STAFF RECOMMENDATION
751 Benton Avenue
August 19, 2015

Application: New construction--outbuilding
District: Woodland-in-Waverly Historic Preservation Zoning Overlay
Council District: 17
Map and Parcel Number: 10510031000
Applicant: Kaitlyn Smous, Allard Ward Architects
Project Lead: Paul Hoffman, paul.hoffman@nashville.gov

Description of Project: Applicant proposed to construct a new garage. The outbuilding is not intended to be a detached accessory dwelling unit (DADU).

1
Site Plan

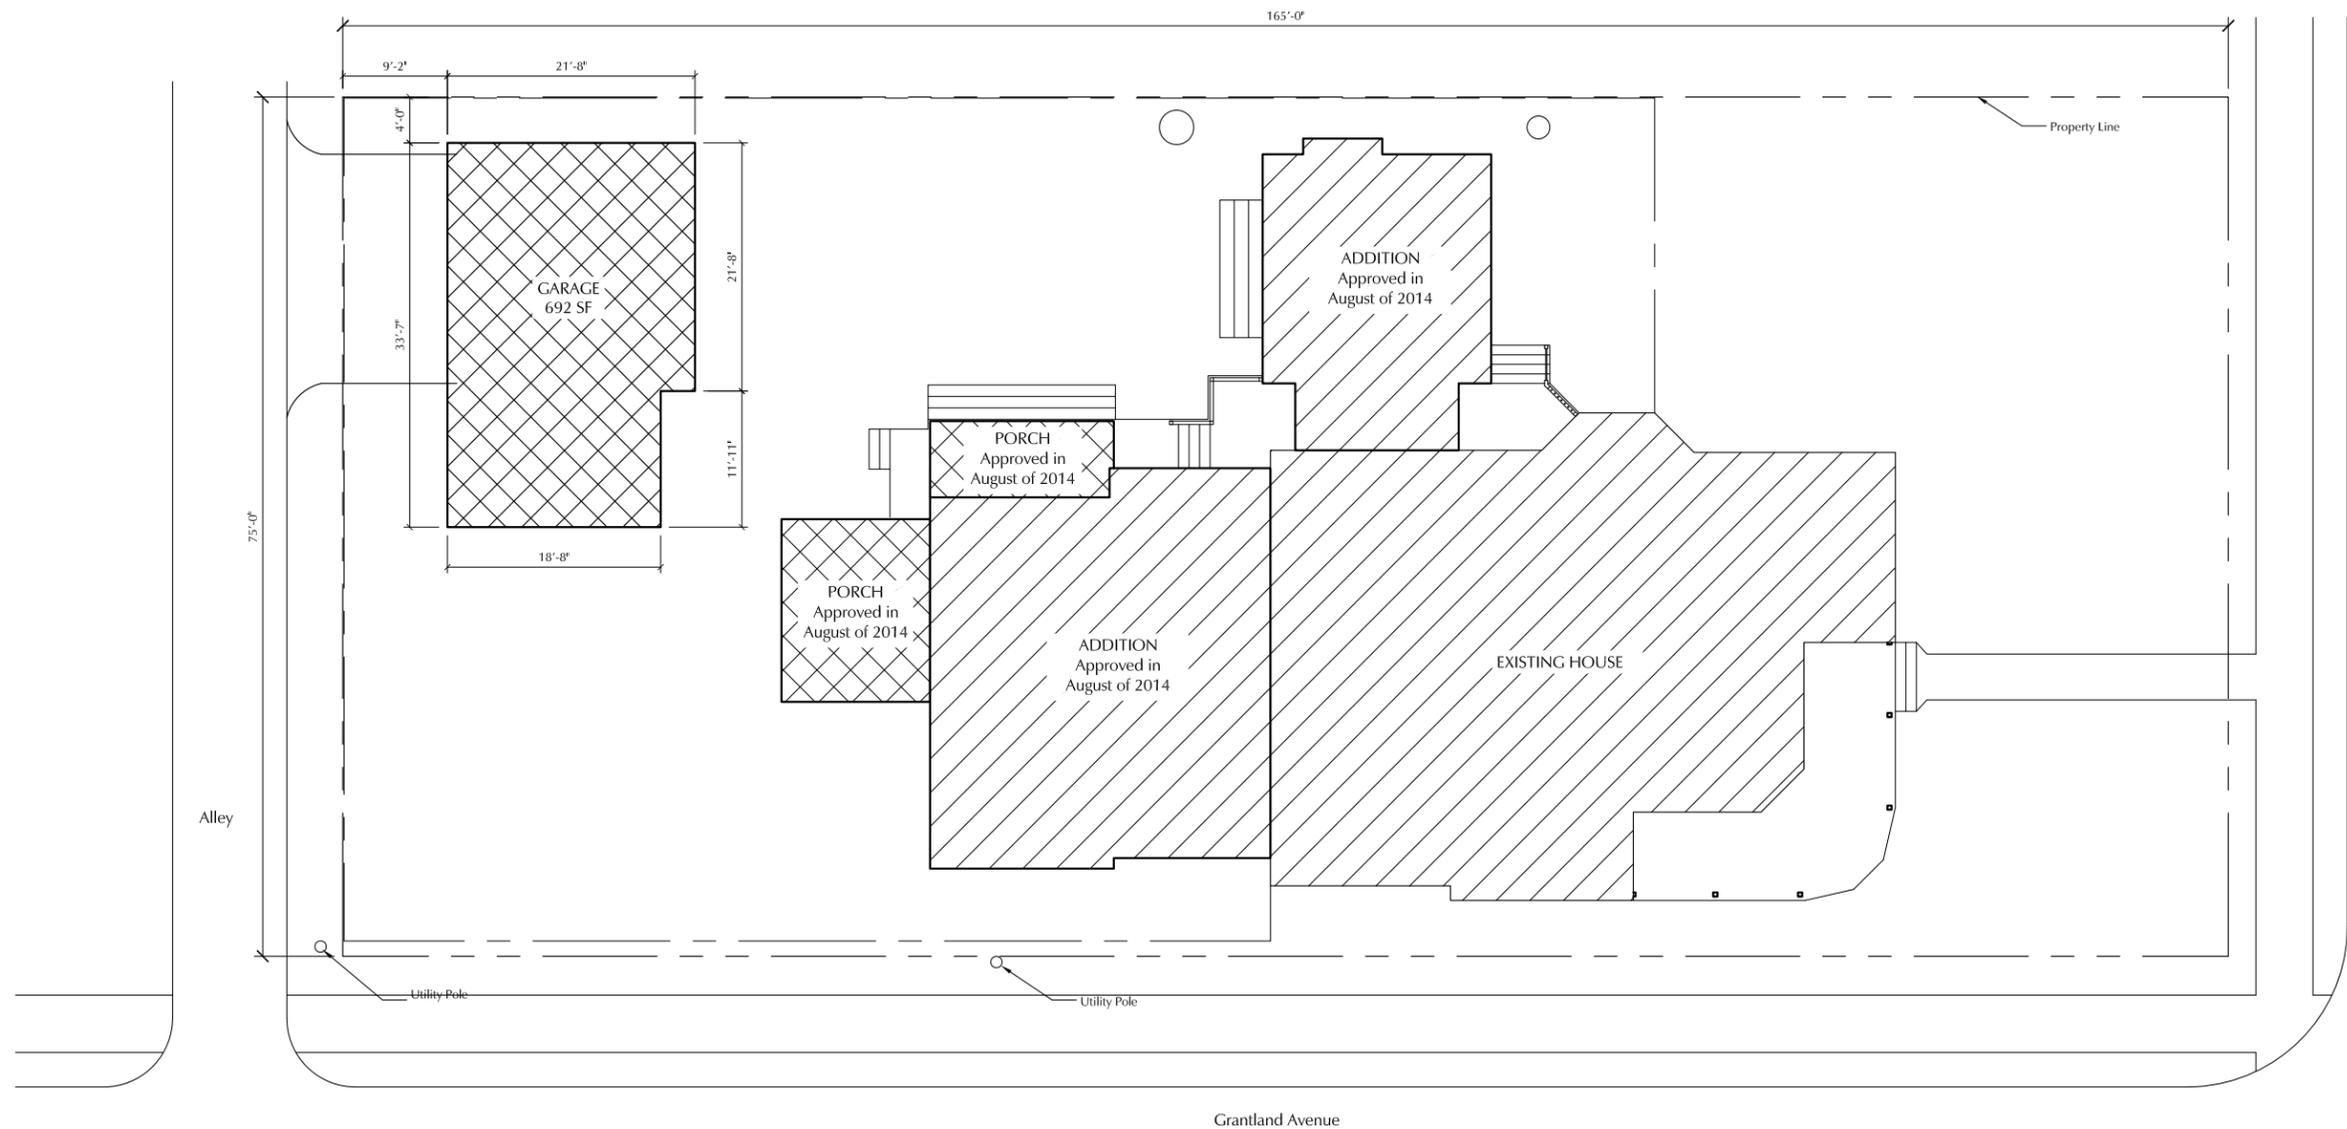
Analysis and Findings: The applicant proposes a new outbuilding at the rear of the lot with a drive facing Grantland Avenue.

Drawings:
 East Elevation
 South Elevation
 Date:
 08.10.15

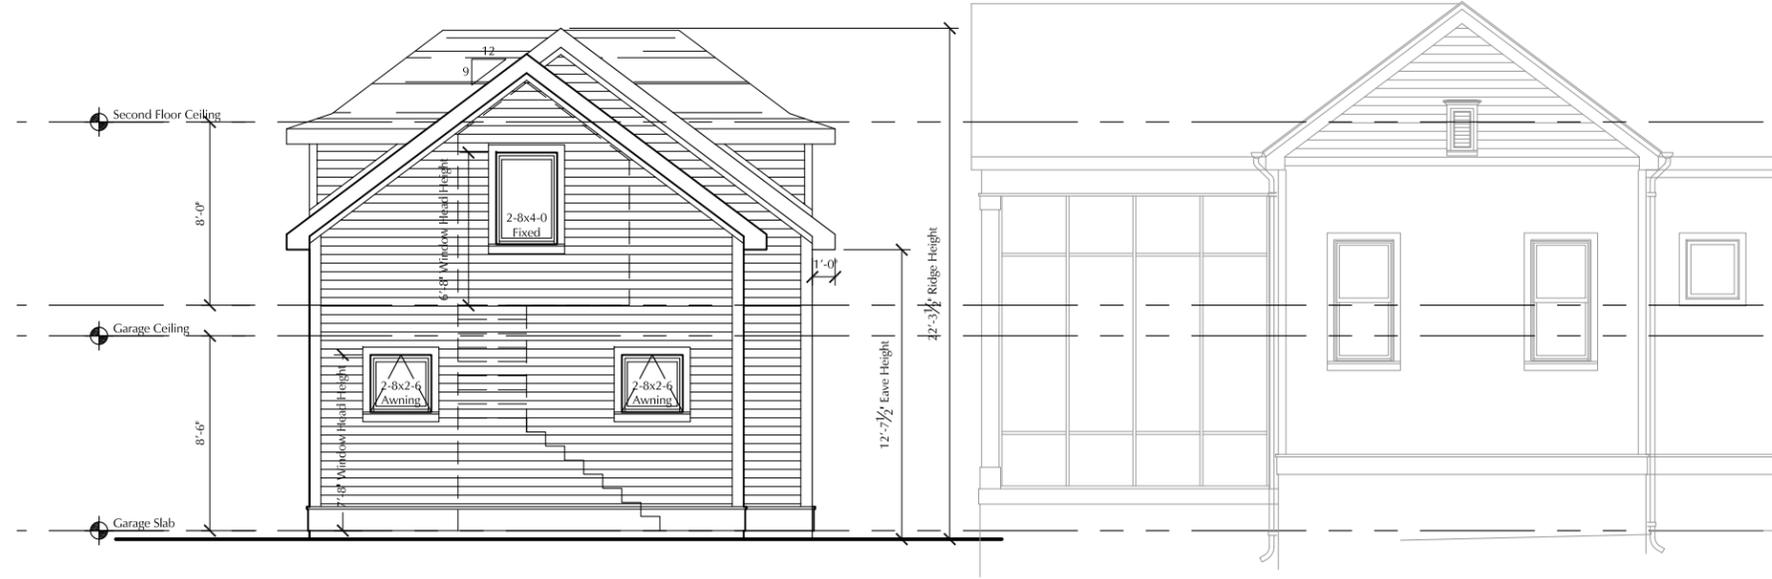
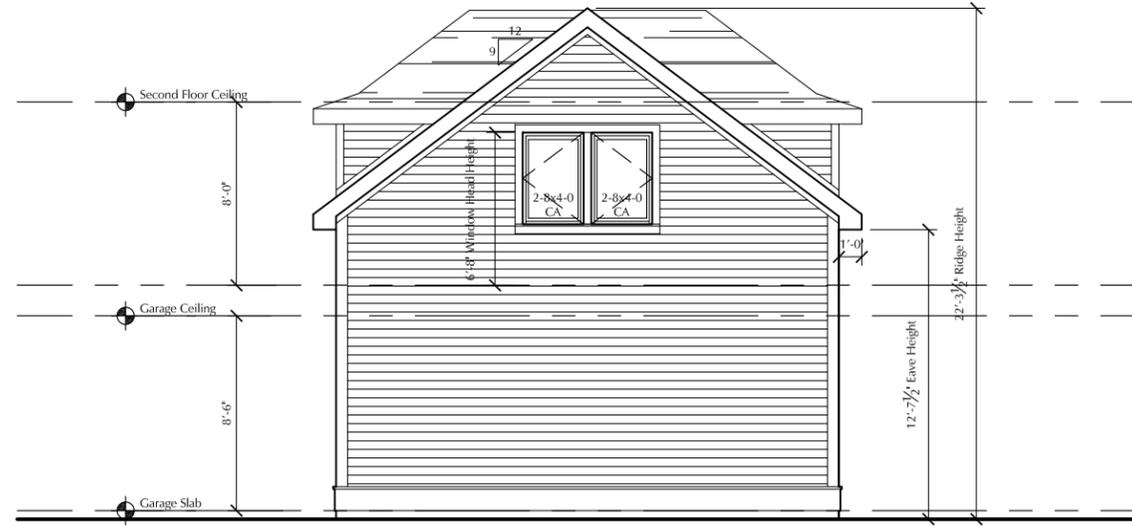
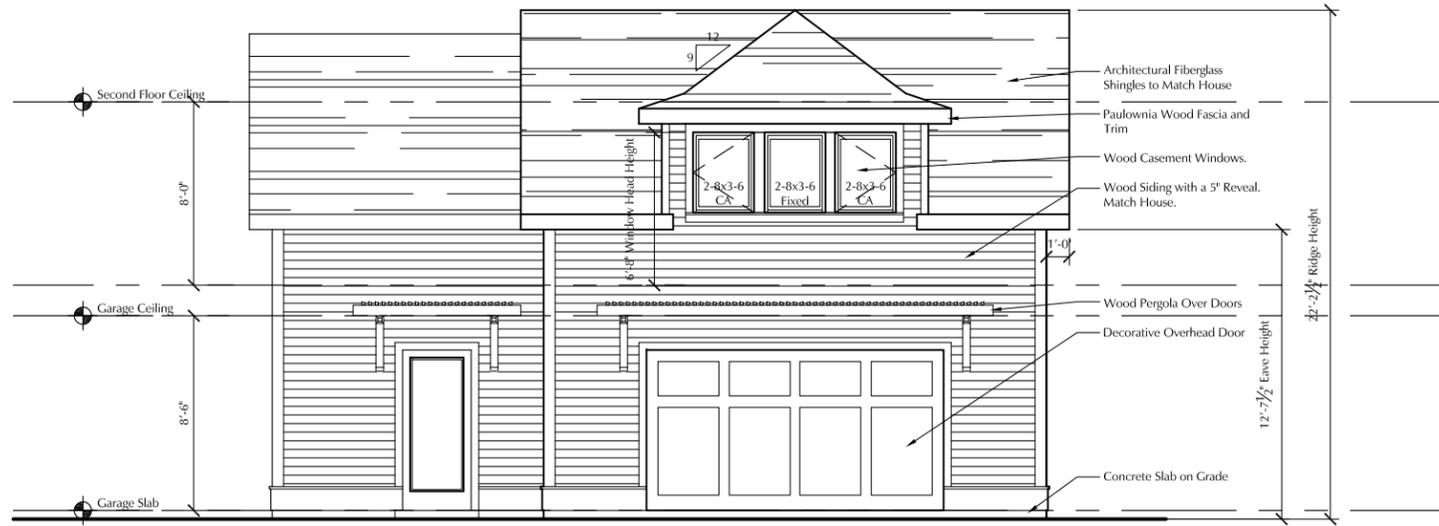
Design: The proposed dormers do not sit two feet (2') off the wall beneath; the Commission has previously approved wall dormers that do not face a public right of way, provided the outbuilding is not intended to be a detached accessory dwelling unit (DADU), which this one is not.

Height and Scale: Although the eave height of twelve feet, eight inches (12'8"), exceeds the maximum of ten feet (10') it is subordinate to the fifteen feet, five inch (15'5") eave height of the house and minimally exceeds the maximum. The Commission has recently approved a similar eave height on an outbuilding that will not be a DADU.

Recommendation: Staff recommends approval with the condition that Staff approves the roof color, and windows and doors prior to purchase and installation. Staff finds the application meets the design guidelines for the Woodland-in-Waverly Historic Preservation Zoning Overlay. *The Commission does not have the authority to*
